22 May 2015

Subject: Comments on United Heckathorn Superfund Site Draft Focused Feasibility Study (FFS)
EPA #: CAD981436363

On behalf of Levin-Richmond Terminal Corp. and Levin Enterprises, Inc. (LRTC), Haley & Aldrich, Inc. and Weiss Associates have prepared the following comments on the *Draft Focused Feasibility Study, United Heckathorn Superfund Site*, Richmond, Contra Costa County, California, prepared by CH2MHill on behalf of the U.S. Environmental Protection Agency (EPA), February 2015, referred to herein as the "Draft FFS."

FIGURE B

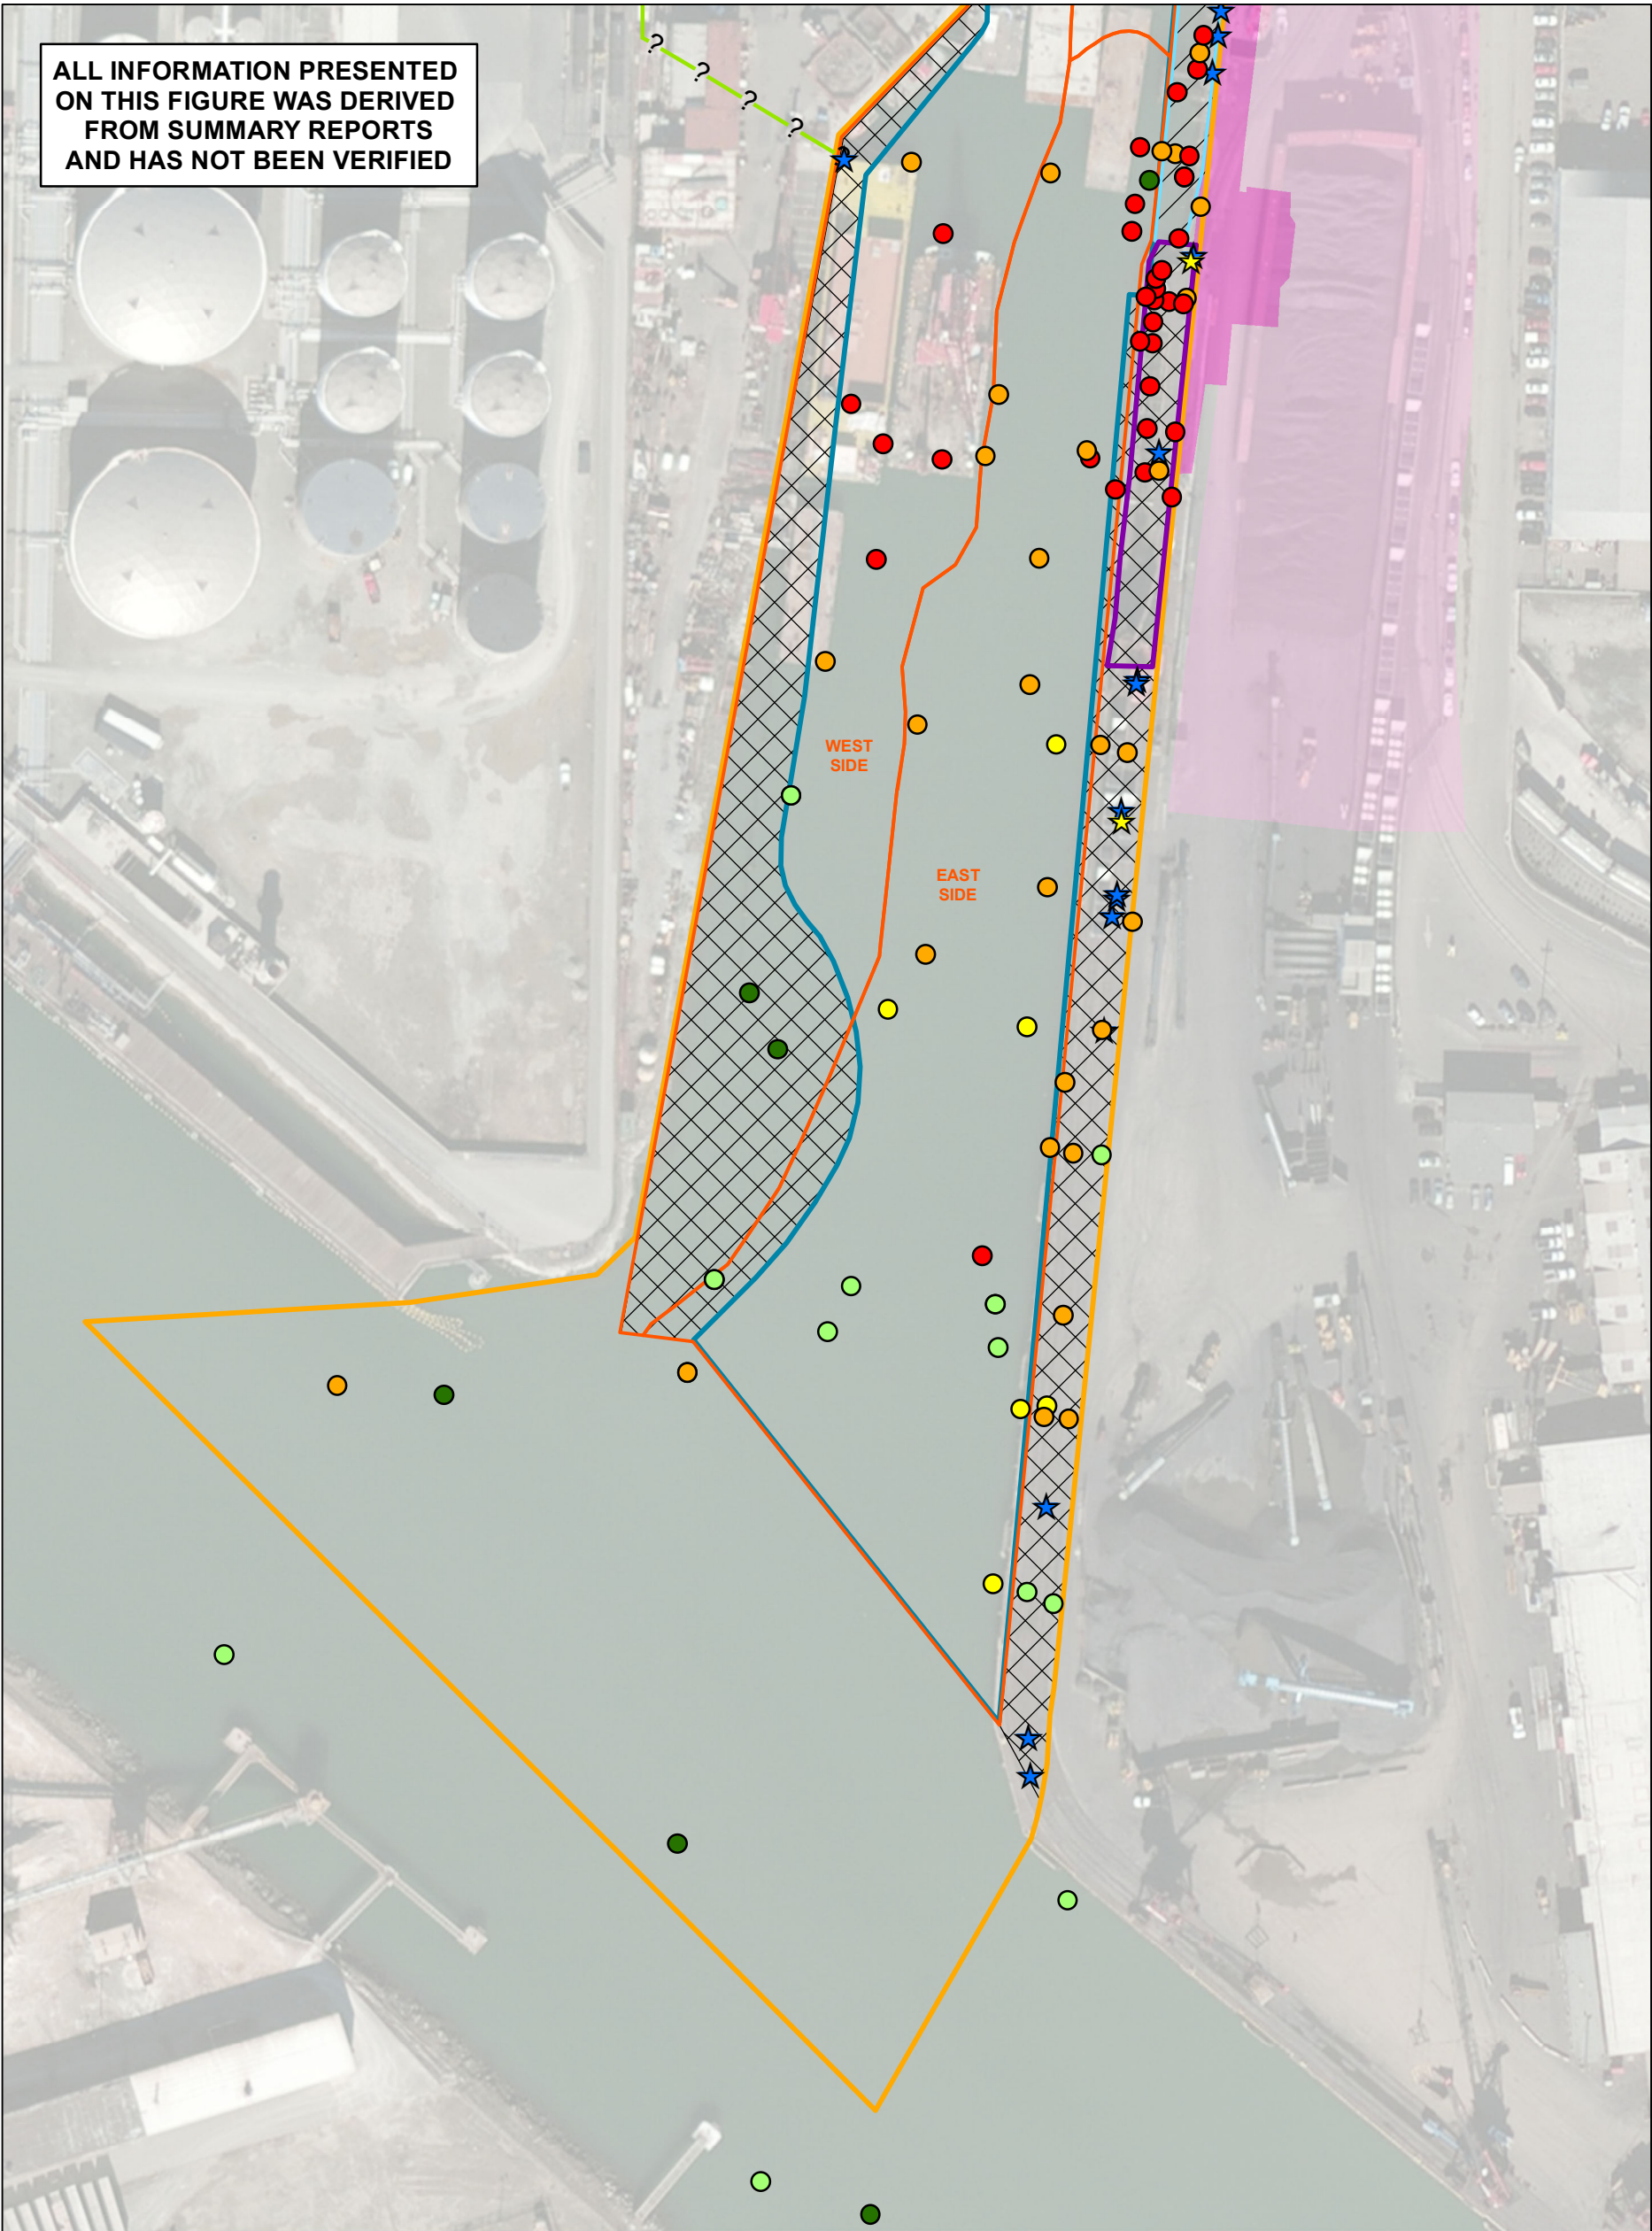
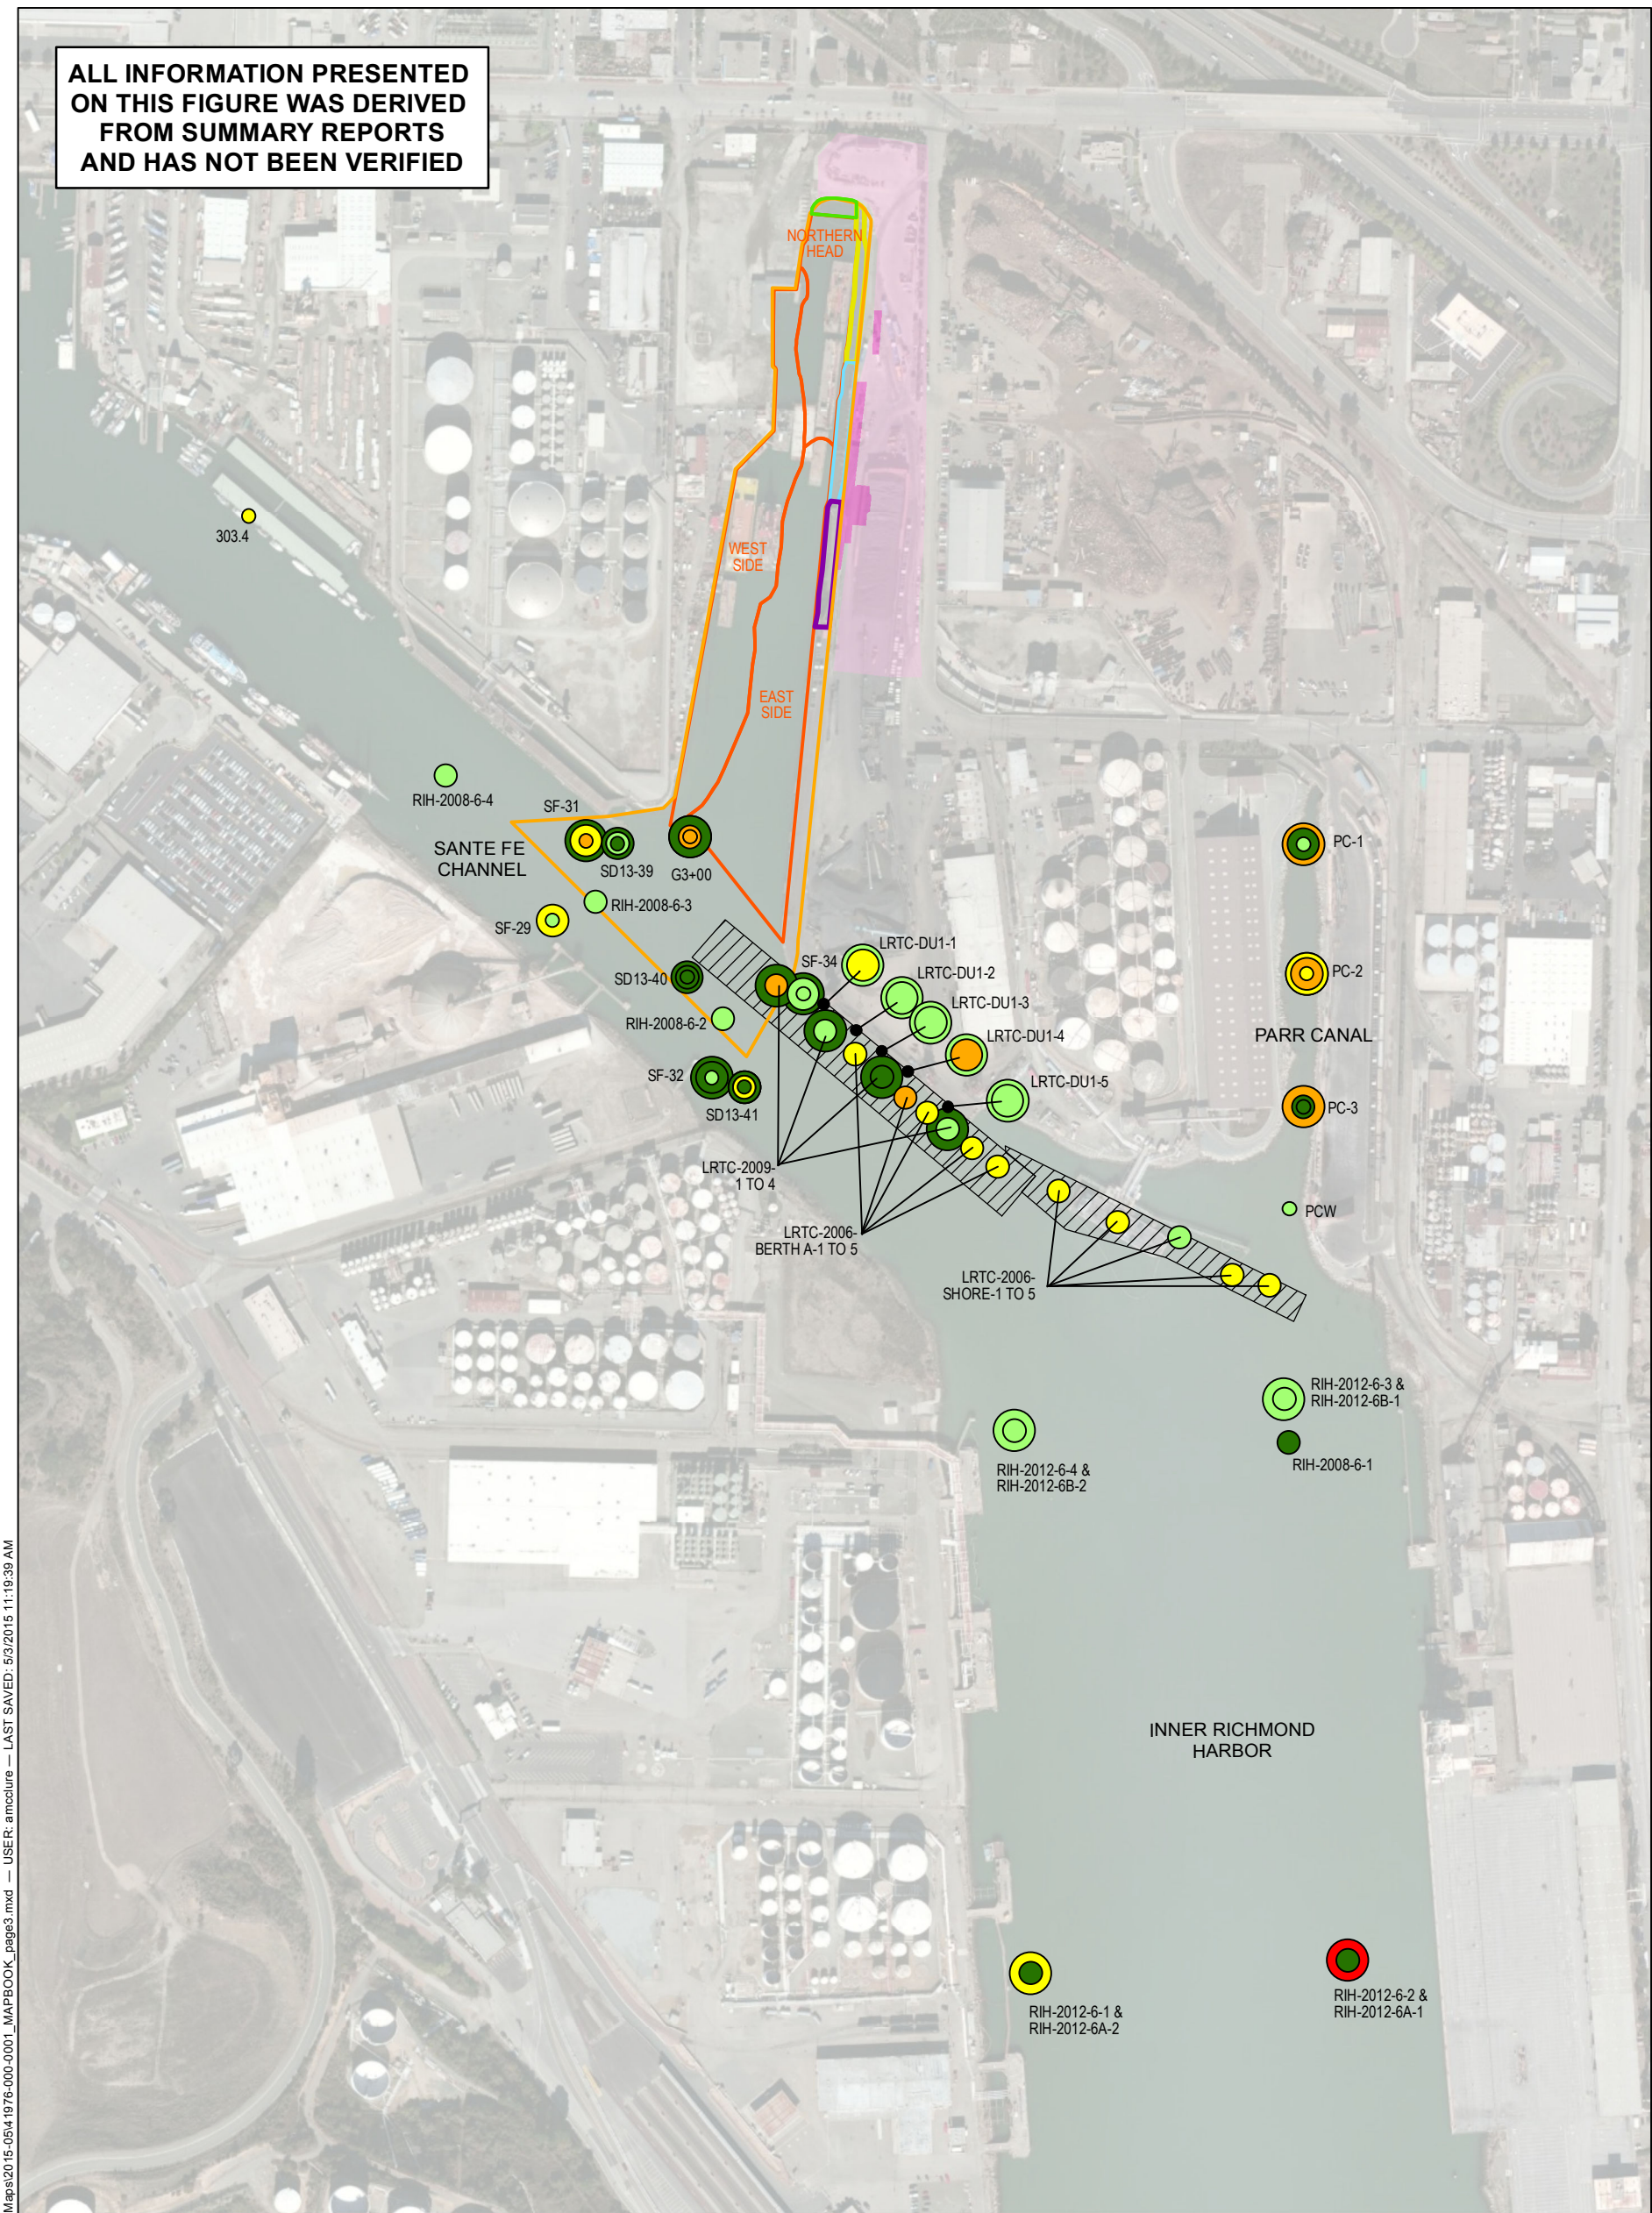
The proposed shoreline remediation areas (Figure 6-1A of the Draft FFS) should be extended to include the entire eastern shoreline of the Lauritzen Channel. Figure B shows that there are at least nine or ten surface samples collected from beneath the Pier but south of the proposed Pier Remediation Area which have total DDT concentrations exceeding the proposed 400 µg/kg RG. The Pier Remediation Area should be extended to include all areas beneath the LRTC Pier, from the Southern Piles Area to the mouth of the Channel.

Significant portions of the system, downstream of the existing samples have not been characterized (shown in light green on Figure B). Nor has the system been adequately mapped. Capping of a catch basin or manhole does not address residual contamination within the pipes left in place. Groundwater infiltration can mobilize that material and transport it to the associated outfall.

FIGURE C

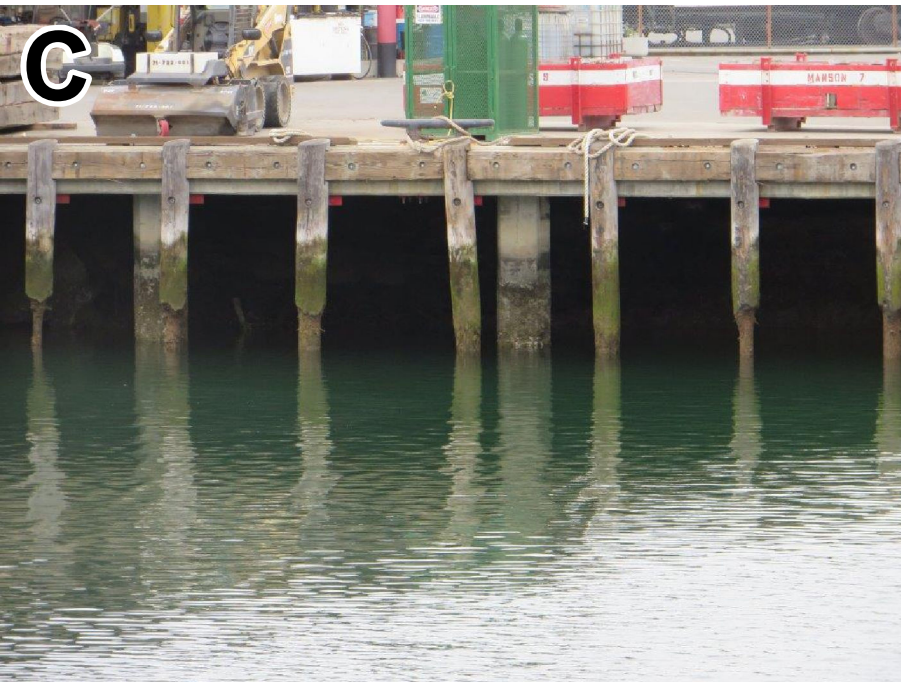
Hydrographic surveys (e.g., Draft FFS Figure 3-1) show sediment accretion at the mouth of the Lauritzen Channel, in the area where the turbidity barrier was installed during the 1996-1997 remediation, suggesting that DDT-impacted sediment suspended during the 1996-1997 dredging may have settled in this area. At least two in-place surface sediment samples, and one recently dredged sample, within the Lauritzen Channel Site boundary, but outside the proposed dredging footprint, had total DDT concentrations exceeding the proposed RG of 400 µg/kg (Figure C). This data gap should be addressed

Additionally, based on RG exceedances observed in whole core homogenates collected off of LRTC Berth A (Figure C), consideration should be given to extending the remediation boundary along the northeastern side of the Santa Fe Channel south of the Lauritzen Channel. This should be evaluated in conjunction with the sampling described above, to delineate of the southern remedial dredge area boundary.

As shown in SIS Figure 8-1, the Lauritzen Channel site boundary includes the shoreline/embankment areas, beginning at the top of the slope on all sides of the Channel (reproduced in Figure C). Addressing all areas of contamination within the Site boundary should be part of the “Remedial Action.” Addressing potential sources of recontamination from outside the Site boundary should be components of the “Source Control” measures.
